Mi2 Technology Demonstration Questions & Answers

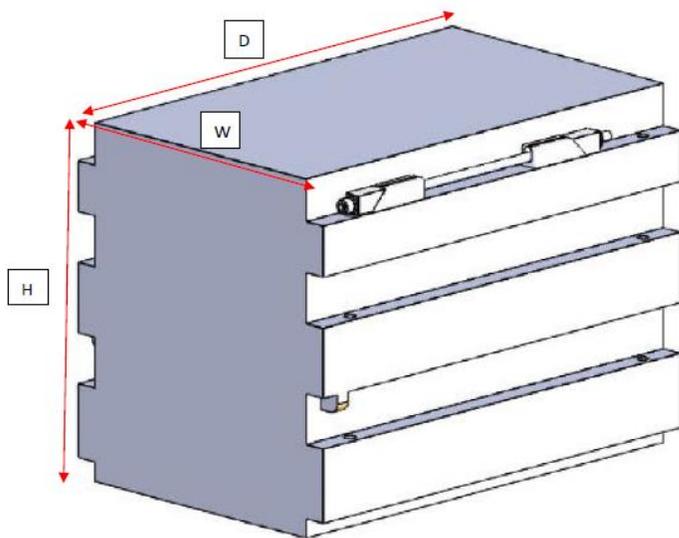
Question #9: Request for System Performance Summary (RSPS) Attribute 2.14 lists a minimum payload bay dimension but is there a maximum allowable dimension?

Answer #9: The above image is representative of a 3U payload. The modular payload specification allows for several standard payload sizes, as defined by 1U, 2U, 3U, etc. For perspective, this is similar to the concept of rack-mounted electronics, but on a smaller scale. The numerical designator indicates the number of “rack spaces” that a payload occupies. While the dimensions of the payloads are controlled by the specification, the “rack” integration will vary from UAS to UAS, based on fuselage design. The dimensions provided in the Request for System Performance Summary (RSPS) are for payload dimensions only, and do not account for the mounting racks. Maximum credit for RSPS Attribute 2.14 will be awarded for an air vehicle which is able to accommodate a payload of dimensions D= 6.15", W= 4.29", H= 7.25".
